**CAMPBELL COUNTY & MUNICIPAL PLANNING & ZONING COMMISSION
MINUTES OF THE DECEMBER 8, 2015 MEETING**

Mr. Verst called for any discussion on unfinished business. Ms. Minter stated there was no unfinished business for the Commission's consideration. Mr. Verst proceeded to new business and introduced case #115-15-SPD-02, a request by COPAC Warehouse Systems, LLC, for approval of a site development plan for additional storage units. Mr. Hutchinson presented the staff report as follows:

FILE NUMBER: 115-15-SPD-02
APPLICANT: COPAC Warehouse Systems, LLC
LOCATION: A 0.996 acre area located at 963 Creektrace Road, Unincorporated Campbell County.
REQUEST: The submitted request is for approval of a Site Plan for storage unit buildings.

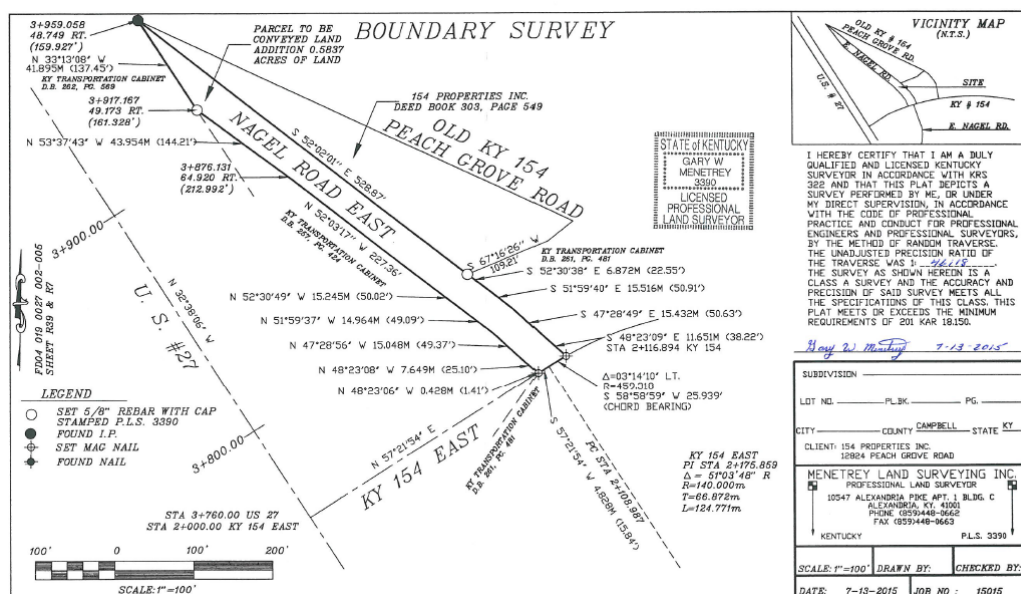
1. A portion of Nagel Road East, located on the south side of Peach Grove Road-Old KY154, west of State Route 154, and east of US 27 in unincorporated Campbell County was removed from service as part of the widening of US 27.
2. Mr. Tim Nolan, the only abutting private property owner has requested the release a portion of former East Nagel Road (red). Mr. Nolan also intends to acquire a portion of property owned by the State (blue). The former East Nagel (red) separates his property from the State (blue) property.
3. A survey has been prepared for the area to be vacated.

The former right-of-way lies between properties owned by Mr. Nolan and the Kentucky Transportation Cabinet. There are no remaining transportation improvements on this site.

In March 2014, the County Maintained Road list was modified by the Fiscal Court based upon the reconstruction and widening of US 27. This reconstruction realigned east Nagel Road and removed this portion of the former roadway. In addition, Mr. Luke Mantle, County Road Supervisor has confirmed that there are no public improvements remaining on the site, the site is no longer in service, and that no inconvenience would result from the discontinuance.

To approve the disposition of land as a public facility and forward the recommendation to the Campbell County Fiscal Court for additional actions.
